**DIRECT TESTIMONY AND EXHIBITS OF****ANTHONY M. SANDONATO****ON BEHALF OF****THE SOUTH CAROLINA OFFICE OF REGULATORY STAFF****DOCKET NO. 2019-224-E****DOCKET NO 2019-225-E****IN RE: SOUTH CAROLINA ENERGY FREEDOM ACT (HOUSE BILL 3659)****PROCEEDING RELATED TO S.C. CODE ANN. SECTION 58-37-40 AND****INTEGRATED RESOURCE PLANS FOR DUKE ENERGY CAROLINAS, LLC****AND DUKE ENERGY PROGRESS, LLC****Q. PLEASE STATE YOUR NAME, BUSINESS ADDRESS AND OCCUPATION.**

**Review of Duke Energy Carolinas, LLC  
2020 Integrated Resource Plan  
Docket No. 2019-224-E**

The South Carolina Office of Regulatory Staff (“ORS”) provides this review of Duke Energy Carolinas, LLC’s (“DEC” or “Company”) 2020 Integrated Resource Plan (“IRP”) filed September 1, 2020, in Docket No. 2019-224-E. In this report (“ORS Report”), when discussed collectively, DEC and its affiliated utility, Duke Energy Progress, LLC (“DEP”), will be referred to as “Duke Energy.”

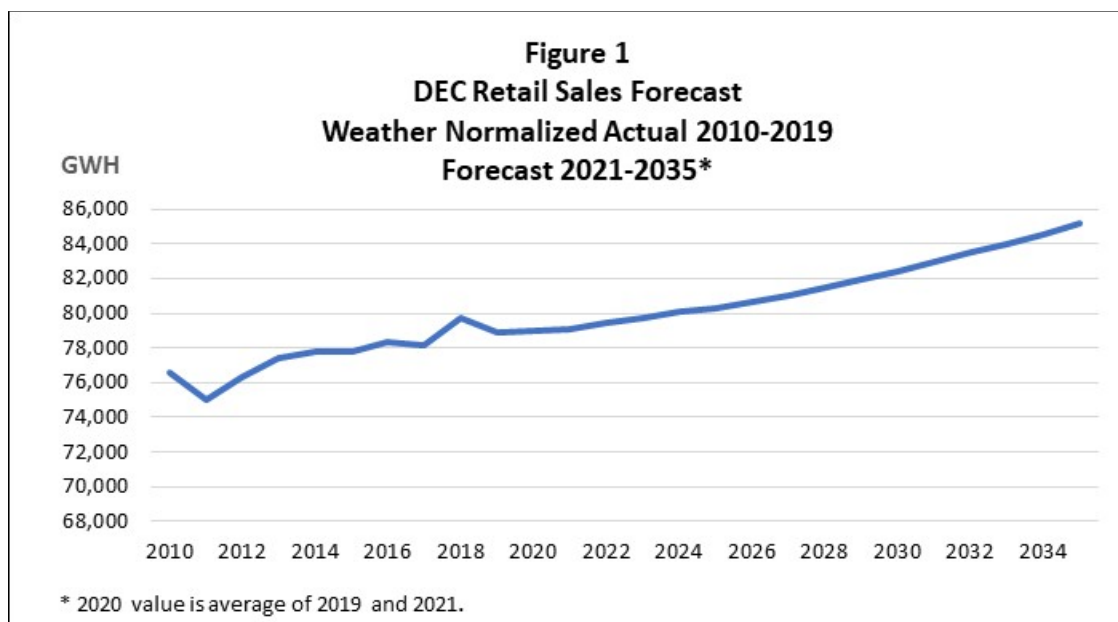
Figure 1 shows the Company's Retail MWh sales forecast for the IRP planning period of 2021 through 2035, together with weather normalized historical retail sales for the period 2010 through 2020.<sup>35</sup> Because wholesale contract requirements changed periodically during the historic period, ORS focused on retail sales (total energy sales less wholesale sales). During the 10-year period through 2019, total weather normalized retail sales grew at only 0.34%, while the Company projects sales growth over the next 15 years to be 0.53%.<sup>36</sup> Essentially, during the past 10 years, DEC has had no retail sales growth. During the forecast horizon, the Company is projecting retail sales growth, primarily in the residential sector.

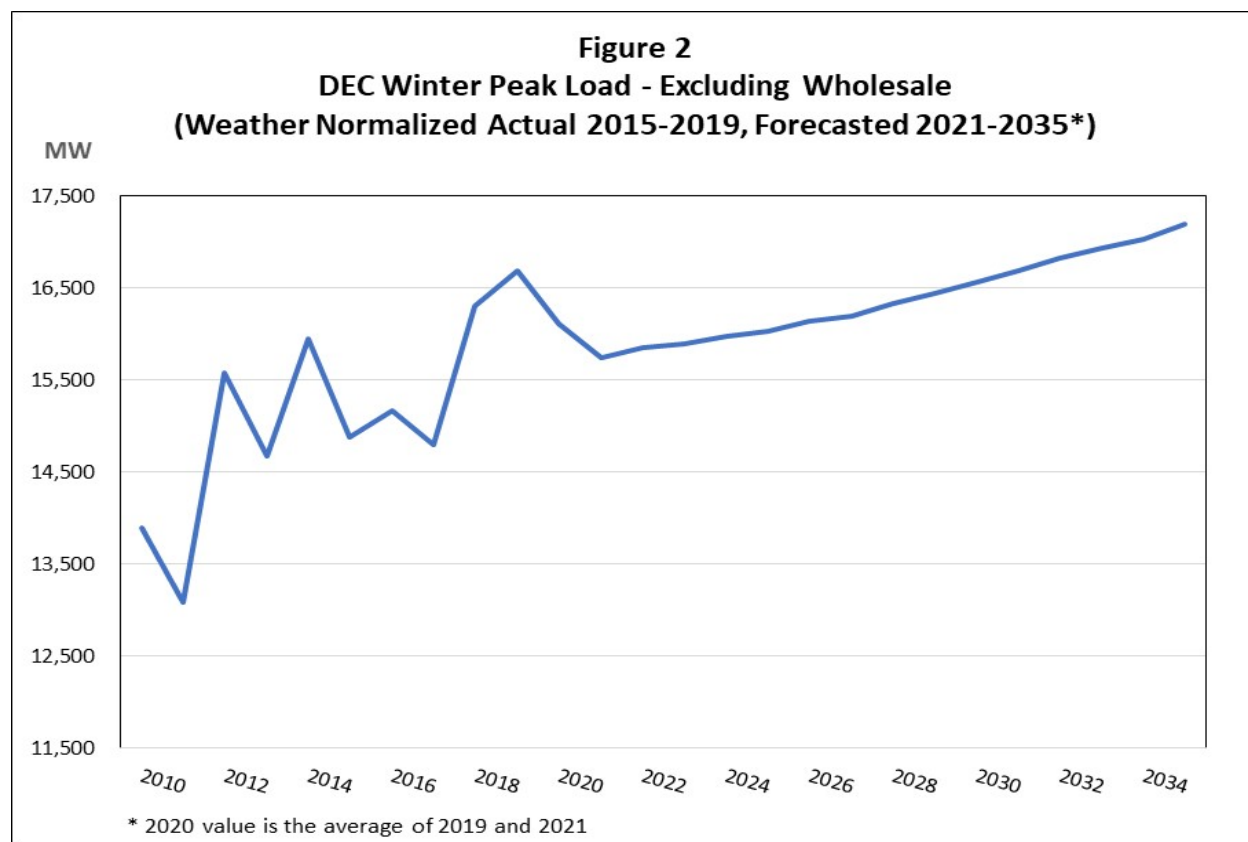
For resource planning purposes, the winter peak demand forecast is the most significant factor. Figure 2 shows the Company's winter peak load forecast, excluding wholesale load, over the IRP planning period of 2021 through 2035, together with corresponding weather normalized historical peaks for the period 2010 through 2020.<sup>37</sup> During the 2010 through 2019 period, winter peak load, excluding wholesale load, grew at 2.1% per year on average, while the Company projects the winter peak load, excluding wholesale load, to grow by 0.6% over the next 15 years.

ORS evaluated the performance of the Company's recent sales and winter peak load forecast on the basis of one-year ahead forecast errors. While a 15-year IRP forecast represents a long-term planning forecast, forecast errors on a one-year ahead basis provide some measure of the performance of the forecasts over a longer term. In particular, given the likely forecast errors associated with the key driving variables, such as income and industrial production, evaluation of a one-year ahead forecast error provides information about the performance of the forecasting models themselves, rather than the performance of the driving variables. Table 5 summarizes the one-year ahead retail energy forecasting error for the period 2014 through 2019. The forecast error is calculated as the percentage difference between the forecast for the next year compared to the weather normalized actual retail energy sales for that year. For example, the retail energy sales forecast prepared in 2014 for 2015 is compared to the weather normalized actual retail energy sales for 2015. Over the six-year period, the average one-year ahead energy forecast error for DEC is an over-forecast of 0.6%. On a combined DEP/DEC base, the average retail energy forecast error is an over-forecast of 0.8%.

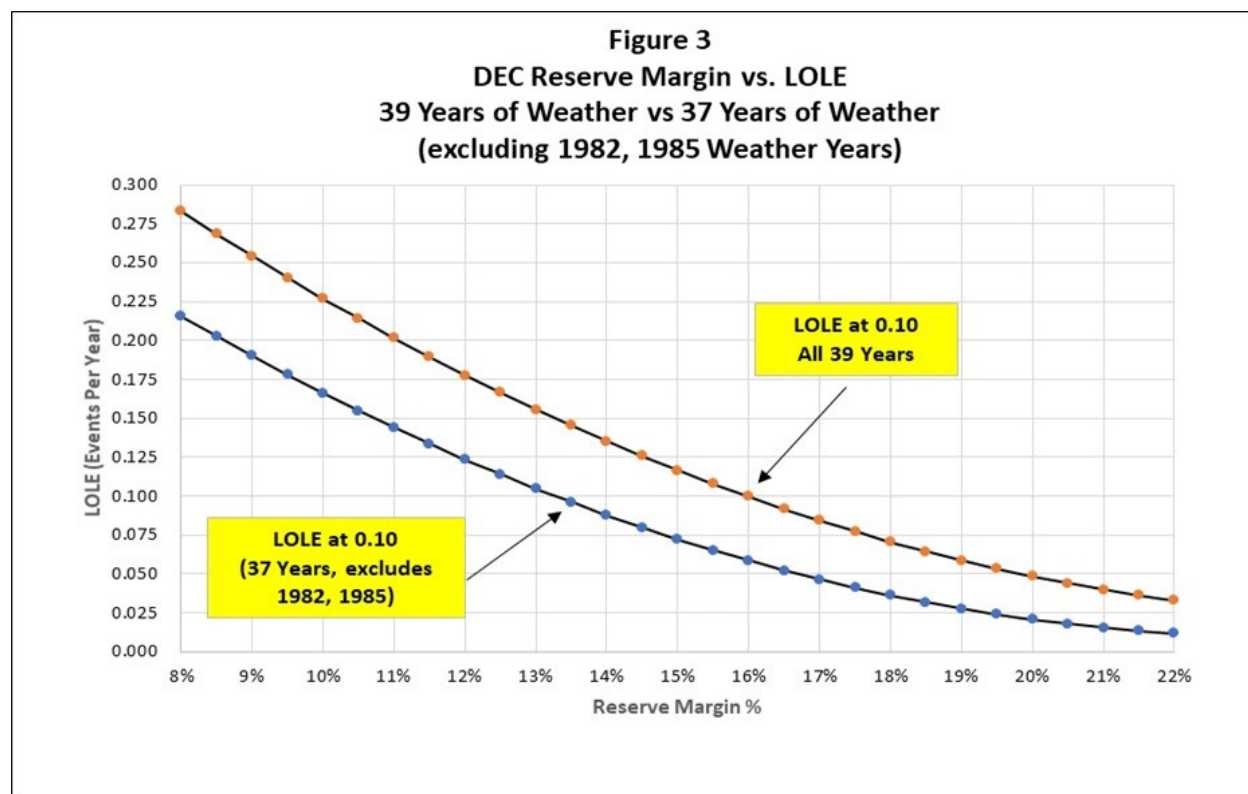
ORS's review of the Company's analysis indicates that the approach used was not unreasonable, though we do have some concerns regarding the ability of the model to accurately measure the effect of extreme low temperatures on load and the impact that may have on the estimation of LOLE.

This issue has a significant impact on the level of required winter reserves needed to maintain an LOLE of 0.10. To examine this impact, ORS recalculated the LOLE analysis developed by the Company under two alternative scenarios: one in which 1982 weather is removed, and another in which both 1982 and 1985 weather are removed from the analysis. The purpose of this analysis is to develop an understanding of the importance of extreme cold weather years on the overall LOLE results, not to suggest or recommend that the LOLE analysis exclude these extreme weather years. The weather in 1982 and 1985 reflected very low winter temperatures. The lowest winter temperatures in the 39-year data base occurred in 1985 for DEC.

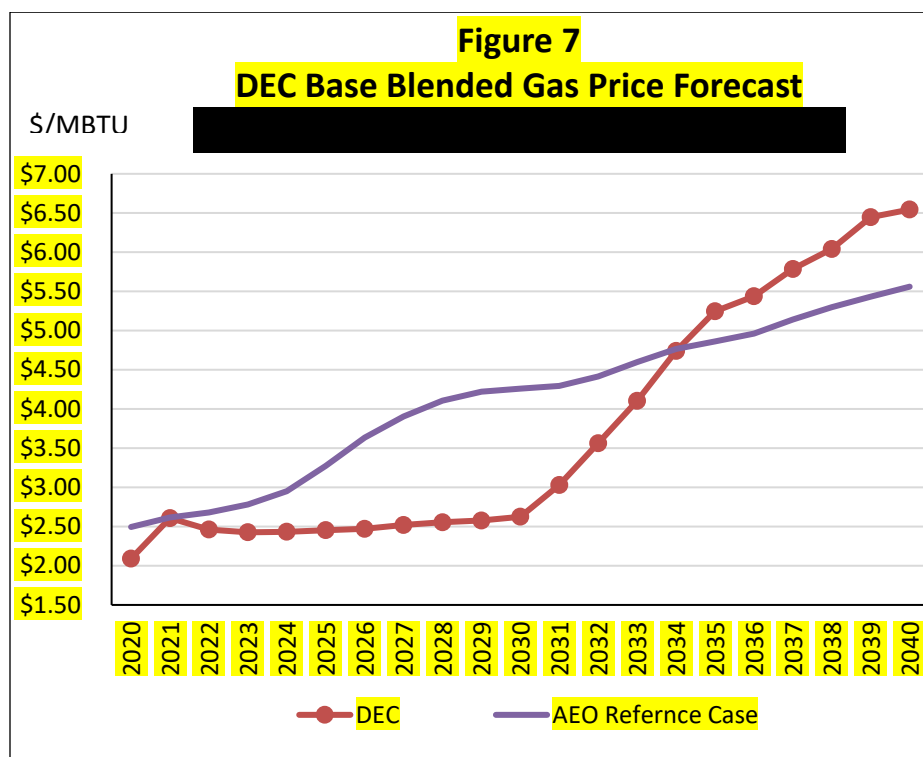
The Company's gas price forecasts are consistently lower than the consensus forecasts in all three (3) cases by a small amount over the period of 2021 to about 2035. After that the DEC forecast actually exceeds the consensus forecast by a small amount in all three (3) cases. ORS recognizes that the future is unknown and that natural gas price forecasts have been lowered considerably over the last ten years. While DEC's forecasts do appear to be a little low over the planning horizon, the important question is whether DEC's forecasts are outliers when compared to the other forecasts, and the answer is no. Some of the other comparable forecasts are actually lower or are close to DEC's forecast over the planning horizon.

While DEC's forecasts do not appear to be unreasonable, there may be an opportunity for improvement. The development of the Company's base gas price forecast is illustrated in the following graph, which shows that the DEC Base forecast is equivalent to the market forecast (NYMEX) until 2030, then trends into the fundamental forecast ( ) until 2035, and follows the fundamental forecast thereafter.

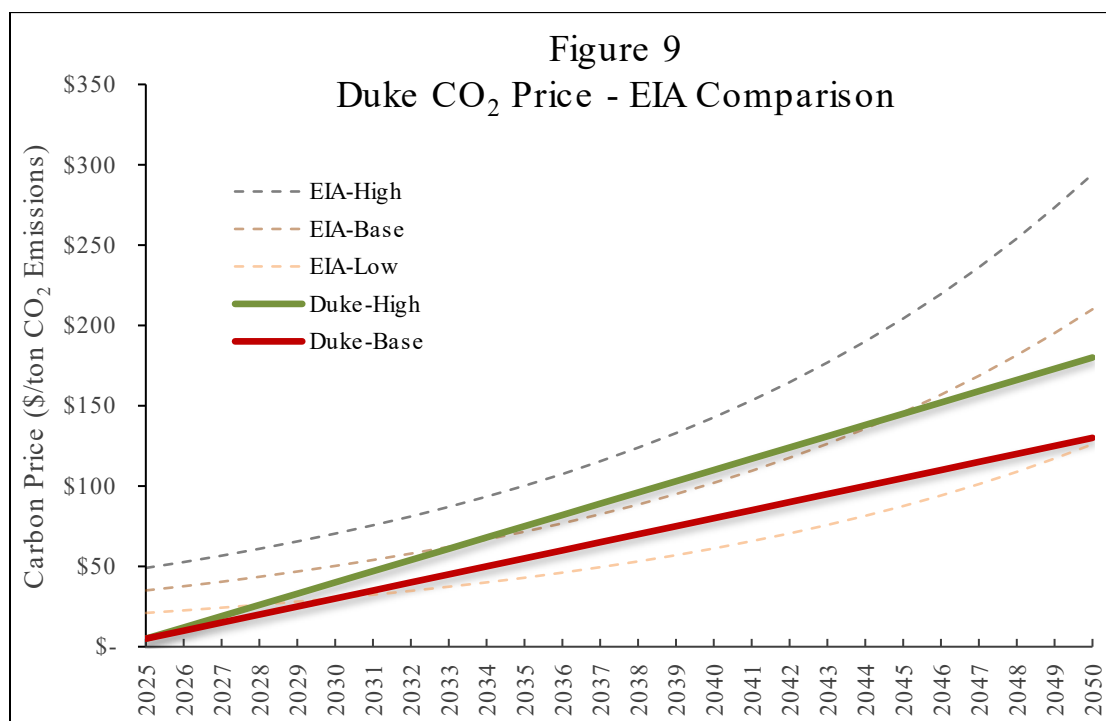
The following figure compares Duke Energy’s forecasts to EIA projections and shows that Duke Energy’s forecasts are reasonably consistent with EIA’s.<sup>73</sup>

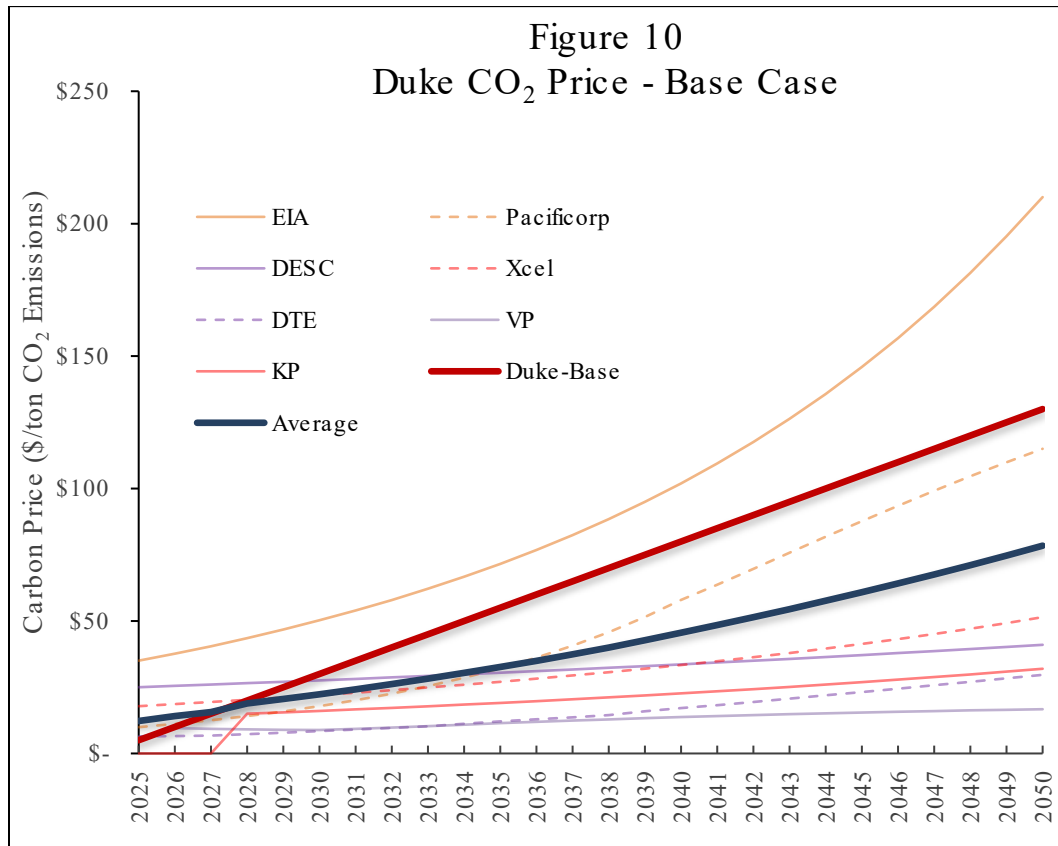
The following figure compares Duke Energy's Base CO<sub>2</sub> forecast to other publicly available base CO<sub>2</sub> utility forecasts and shows that Duke Energy's forecasts are also reasonably consistent with those forecasts, though in fact, Duke Energy's forecast is higher than the average of the forecasts. The other utility forecasts include PacifiCorp,<sup>74</sup> DESC,<sup>75</sup> Xcel Energy,<sup>76</sup> DTE Electric,<sup>77</sup> Virginia Power,<sup>78</sup> and Kentucky Power,<sup>79</sup> and the average of each forecast (including Duke Energy's).

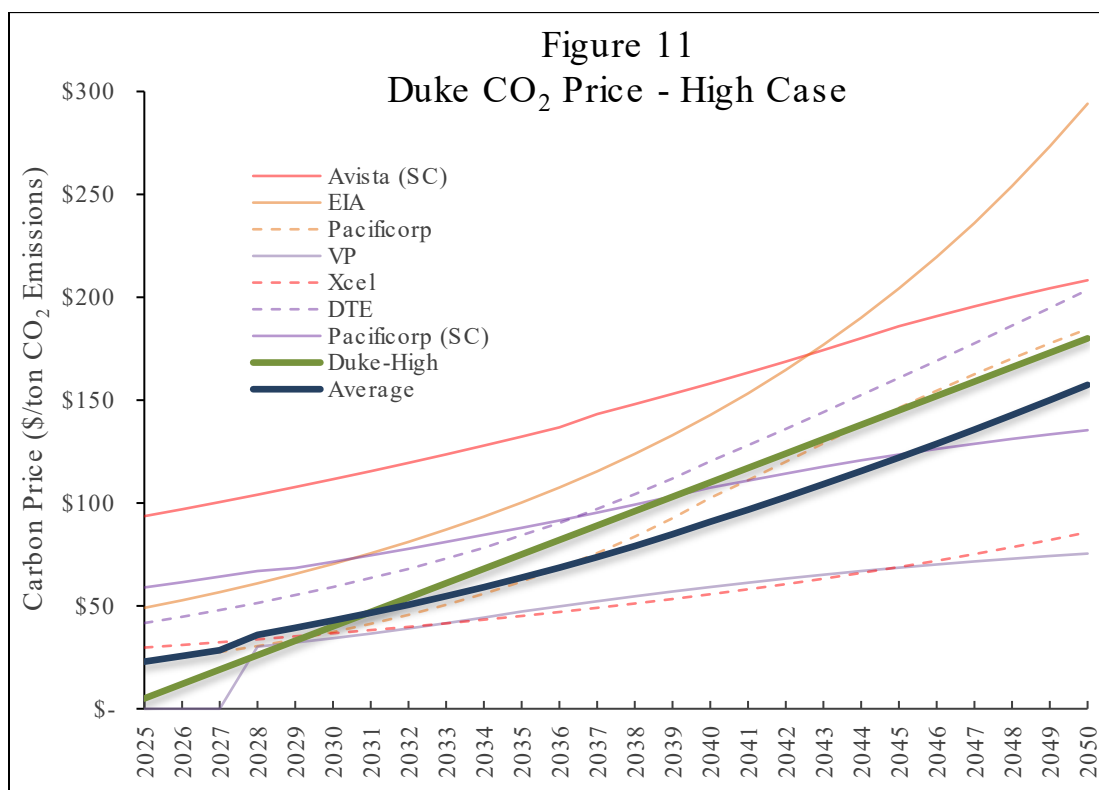
Lastly, the following figure compares Duke Energy's High CO<sub>2</sub> forecast to the other publicly available high CO<sub>2</sub> utility forecasts and shows that Duke Energy's forecast is once again reasonably consistent with the other forecasts, though in fact, Duke Energy's forecast is higher than the average of the forecasts.

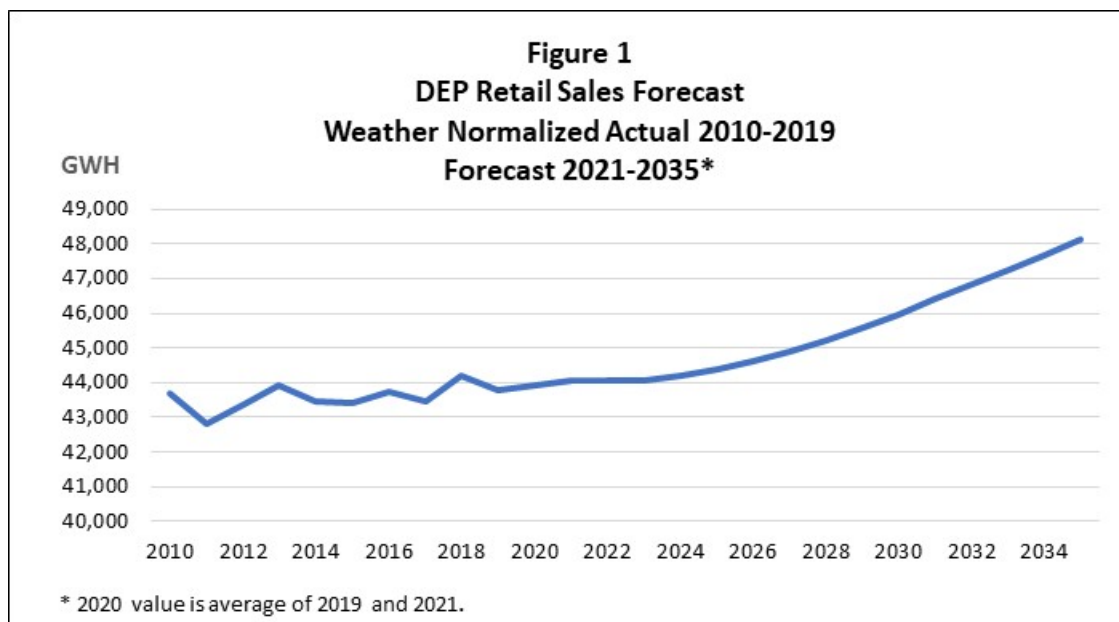
Figure 1 shows the Company's Retail MWh sales forecast for the IRP planning period of 2021 through 2035, together with weather normalized historical retail sales for the period 2010 through 2020.<sup>35</sup> Because wholesale contract requirements changed periodically during the historic period, ORS focused on retail sales (total energy sales less wholesale sales). During the 10-year period through 2019, total weather normalized retail sales grew at only 0.02%, while the Company projects sales growth over the next 15 years to be 0.63%.<sup>36</sup> Essentially, during the past 10 years, DEP has had no retail sales growth. During the forecast horizon, the Company is projecting retail sales growth, primarily in the residential sector.

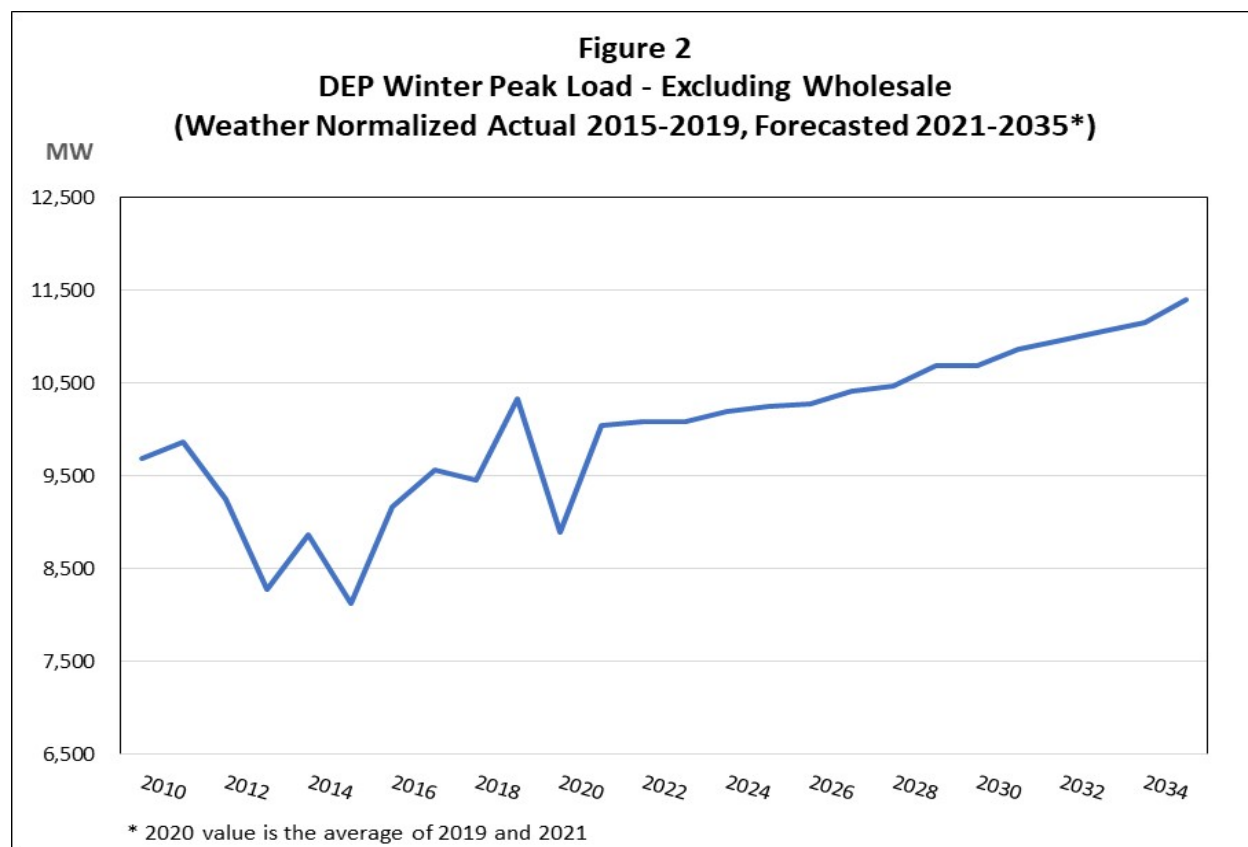
For resource planning purposes, the winter peak demand forecast is the most significant factor. Figure 2 shows the Company's winter peak load forecast, excluding wholesale load, over the IRP planning period of 2021 through 2035, together with corresponding weather normalized historical peaks for the period 2010 through 2020.<sup>37</sup> During the 2010 through 2019 period, winter peak load, excluding wholesale load, grew at 0.7% per year on average, while the Company projects the winter peak load, excluding wholesale load, to grow by 0.9% over the next 15 years.

ORS evaluated the performance of the Company's recent sales and winter peak load forecast on the basis of one-year ahead forecast errors. While a 15-year IRP forecast represents a long-term planning forecast, forecast errors on a one-year ahead basis provide some measure of the performance of the forecasts over a longer term. In particular, given the likely forecast errors associated with the key driving variables, such as income and industrial production, evaluation of a one-year ahead forecast error provides information about the performance of the forecasting models themselves, rather than the performance of the driving variables. Table 5 summarizes the one-year ahead retail energy forecasting error for the period 2014 through 2019. The forecast error is calculated as the percentage difference between the forecast for the next year compared to the weather normalized actual retail energy sales for that year. For example, the retail energy sales forecast prepared in 2014 for 2015 is compared to the weather normalized actual retail energy sales for 2015. Over the six-year period, the average one-year ahead energy forecast error for DEP is an over-forecast of 1.0%. On a combined DEP/DEC base, the average retail energy forecast error is an over-forecast of 0.8%.
